# Origination Form

## Proposed Revisions to a Standard Plans Index

<b>Originator:</b>	Turley, Joshua	<b>Index Number:</b>	521-660
<b>Date:</b>	5/14/2024	<b>Sheet Number(s):</b>	2, 4
<b>E-mail:</b>	Joshua.Turley@dot.state.fl.us	<b>Index Title:</b>	LIGHT POLE PEDESTAL - BRIDGE

OPTION 2 - TYPICAL SECTION AT LIGHT POLE PEDESTAL (Approach Slab Similar)

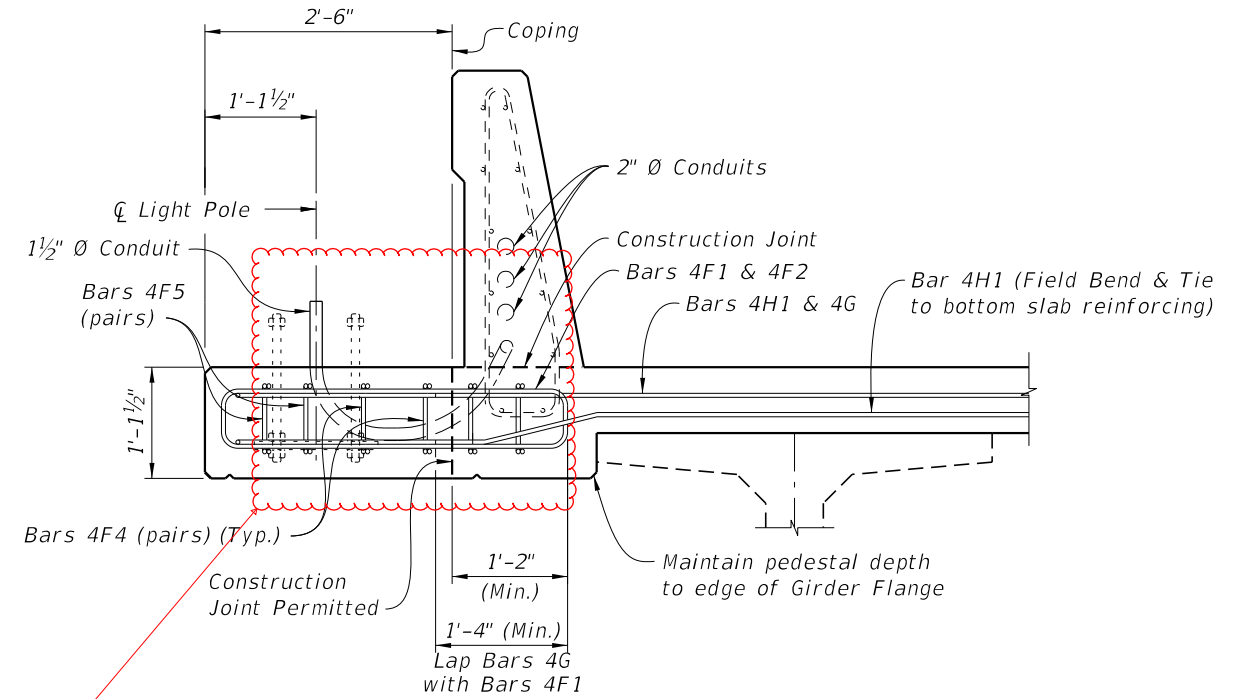
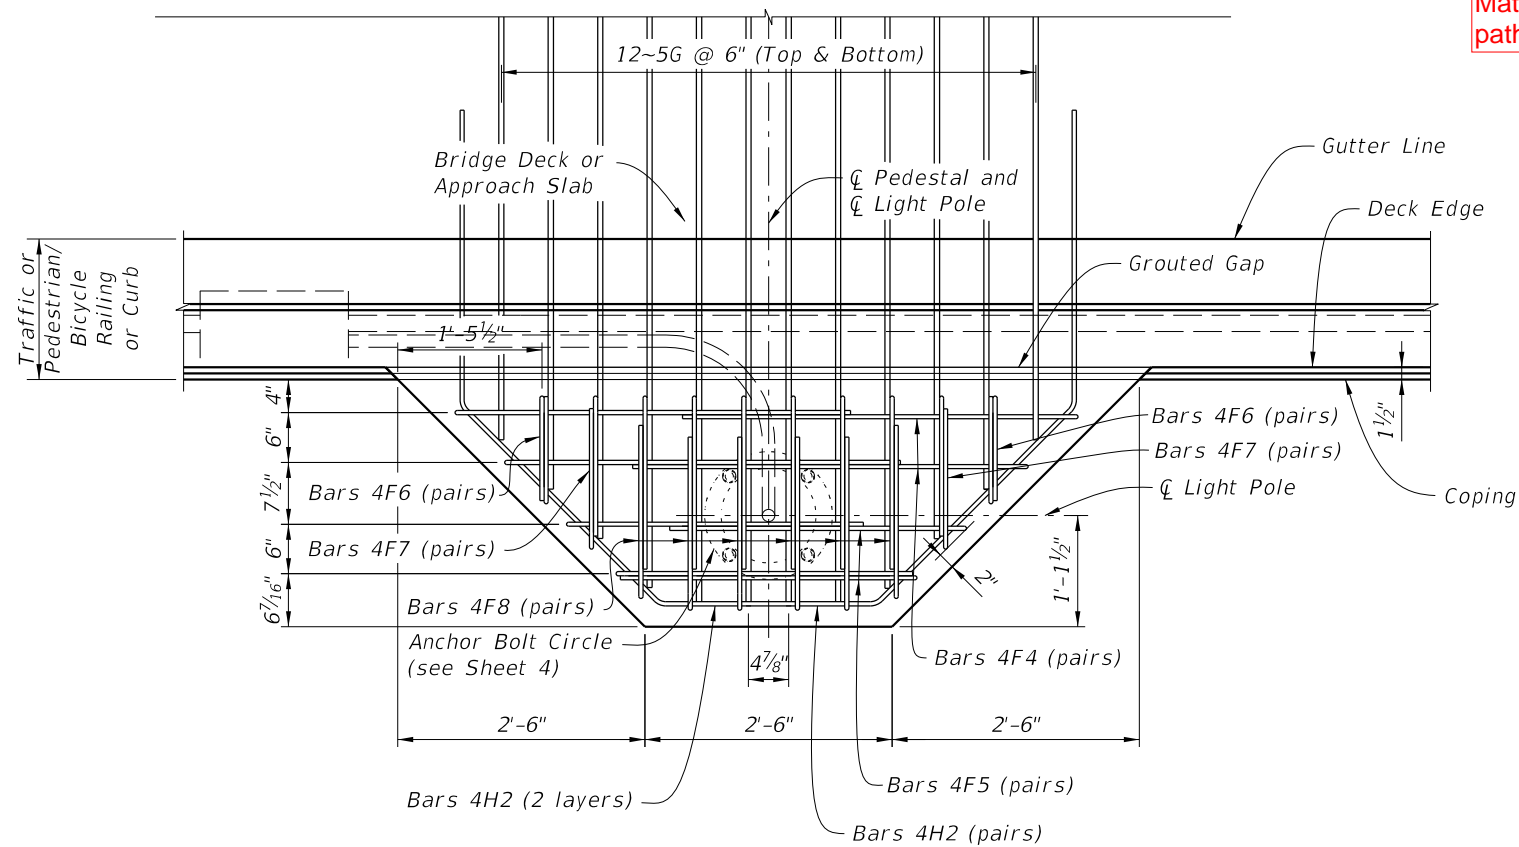
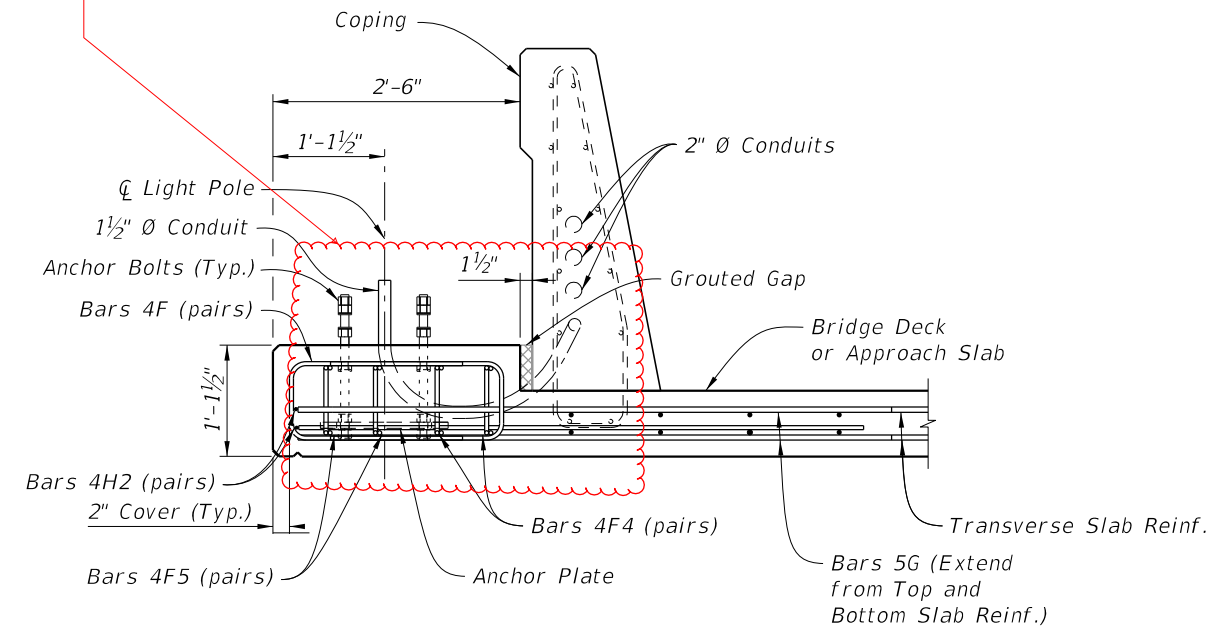
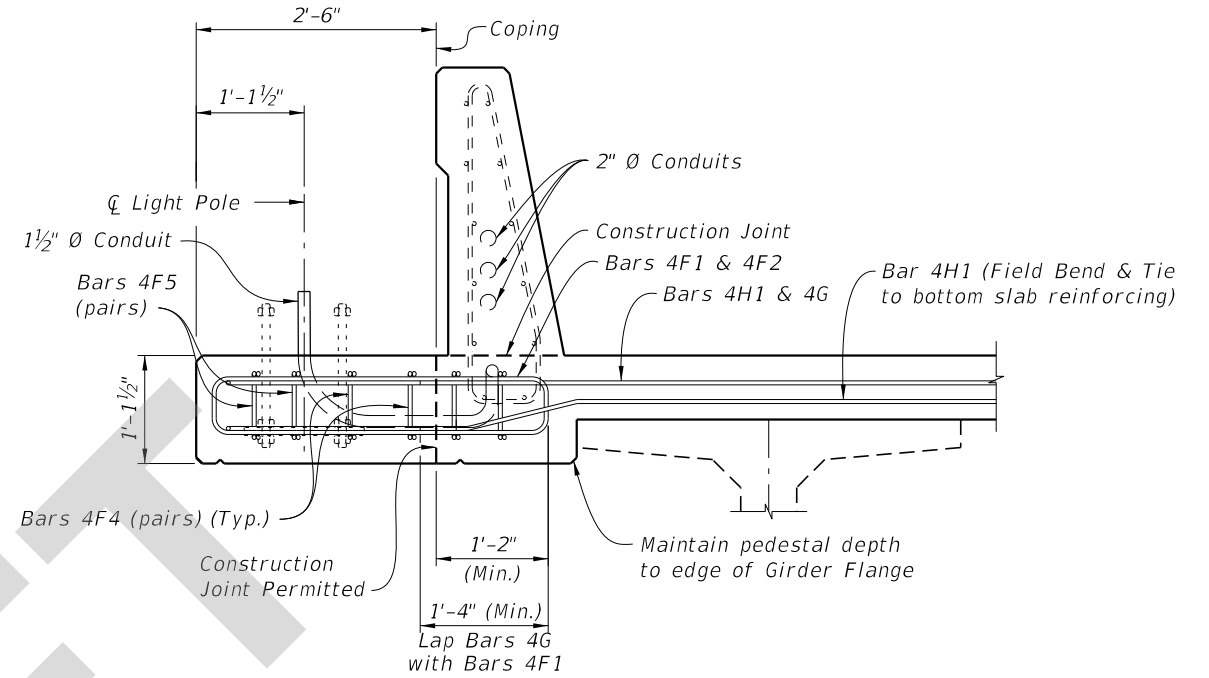
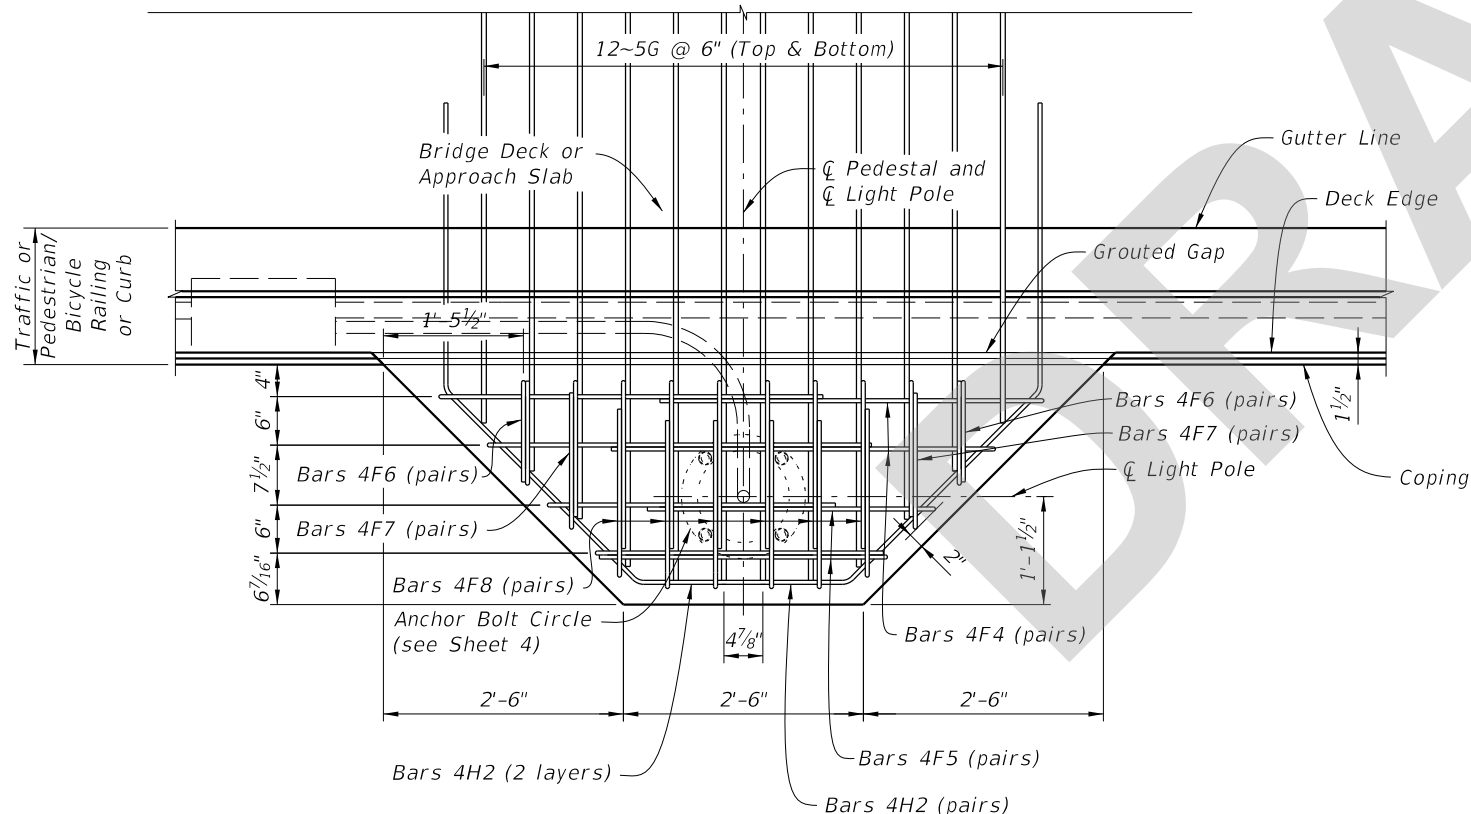
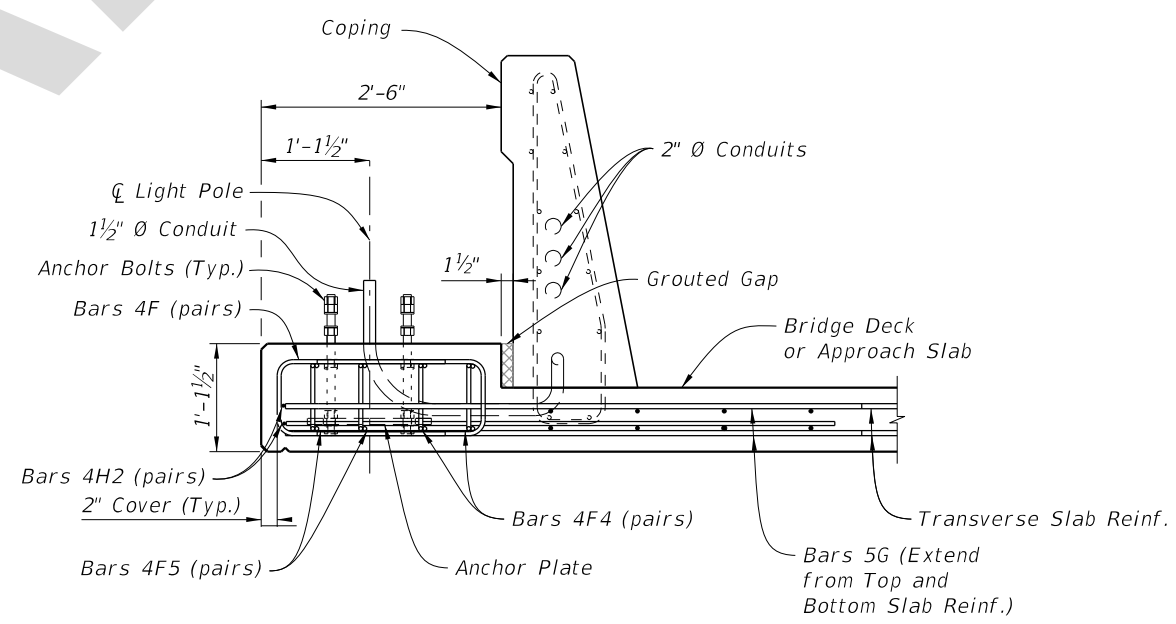
Sheet 2: Revised conduit path for the TYPICAL SECTION's.  
 Sheet 4: Labeled the anchor bolt nuts in DETAIL "A"; Added a note for DETAIL "A" regarding minimum anchor bolt embedment and bottom concrete cover; Removed anchor bolt table; Revised Note 4 to now include maximum deck height, pole height, and pole arm length

Sheet 1: Conduit path was slightly incorrect so we fixed it.  
 Sheet 4: The anchor bolt nuts were labled to correspond with the Spec. The anchor bolt table was removed so that this Index will only address the standardized pole and pedestal capacities. The pole mounting height is limited to 40 feet for an elevated structure mount.

Match the conduit curvature path of sheet 1 option 1.

DETAIL "A"

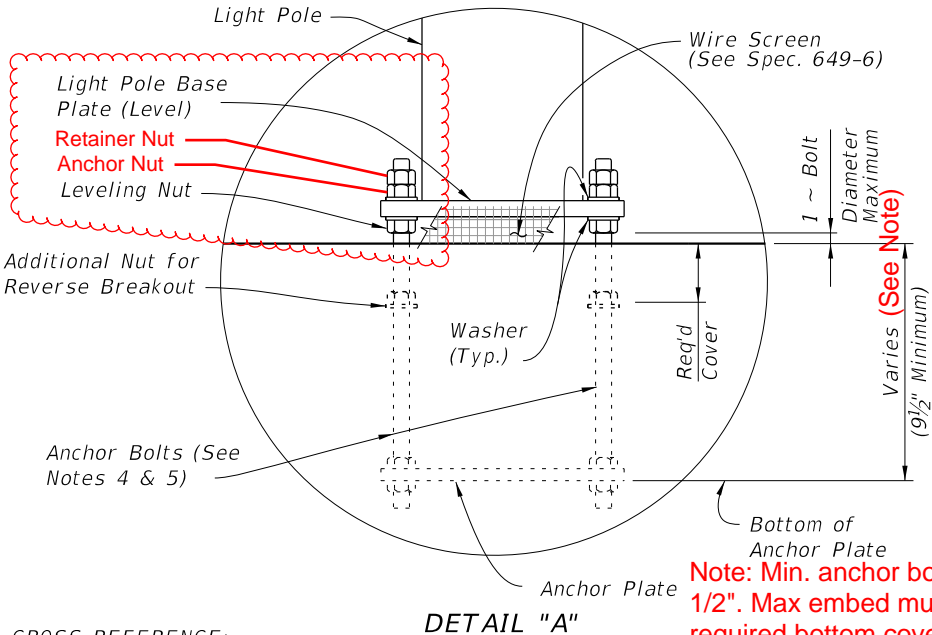
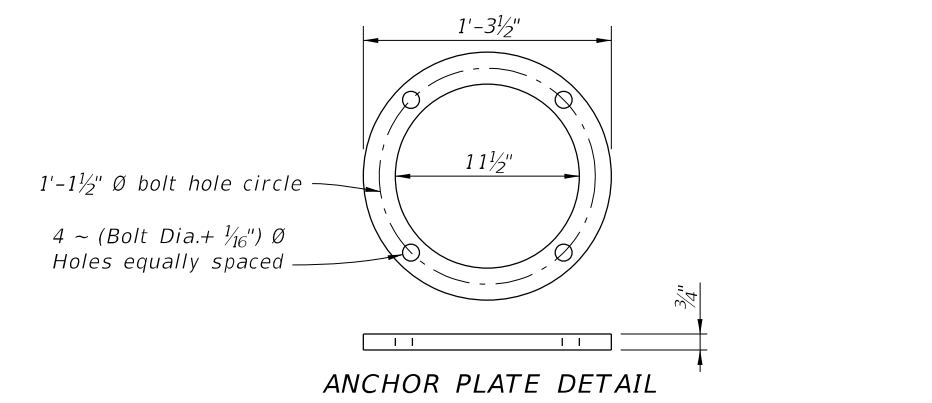
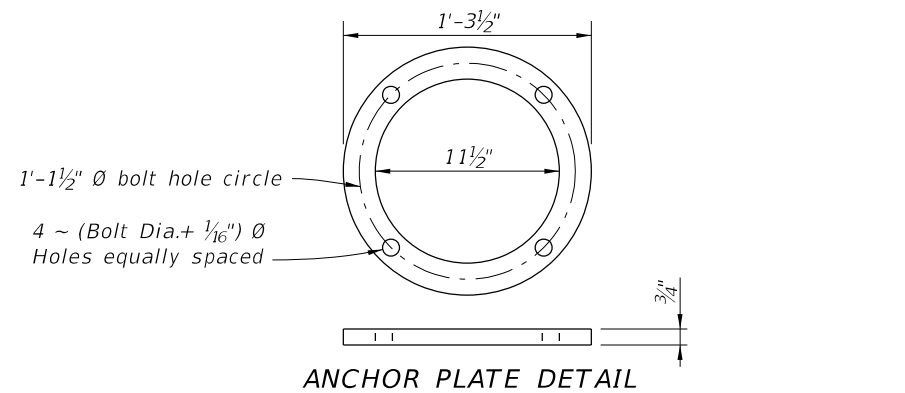
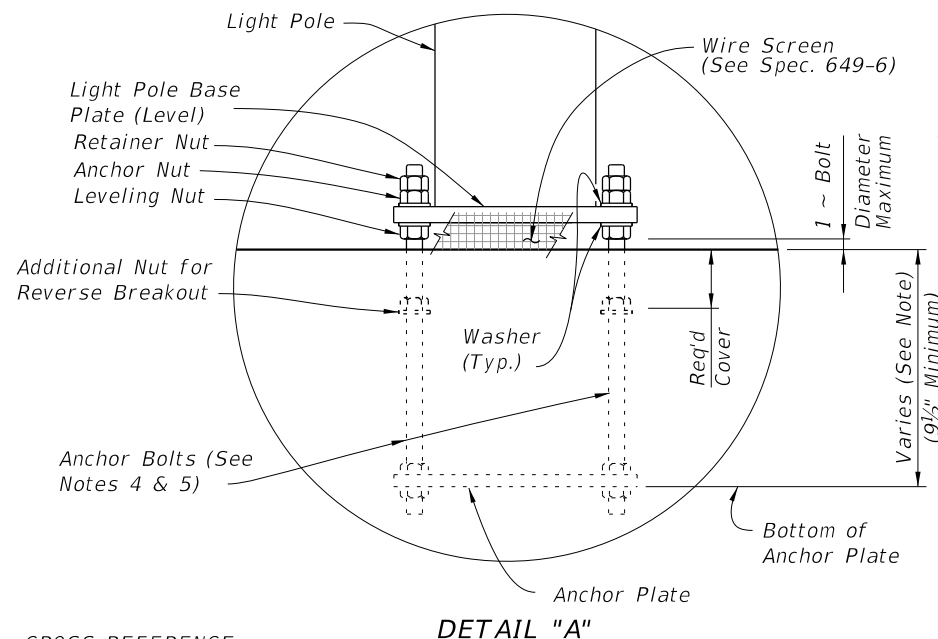
Note: Min. anchor bolt embed is 9 1/2". Max embed must maintain min. required bottom cover. Anchor bolt embed max. may be as long as required for constructability depending on which pedestal option is used.

Anchor Bolt design is based on the standard Roadway Aluminum Light Pole configurations shown on Index 715-002 with a maximum 40 ft. luminaire mounting height and a maximum 12 ft. arm length. Use 1" Ø anchor bolt for up to 75 ft. bridge deck height above natural ground or MLW.
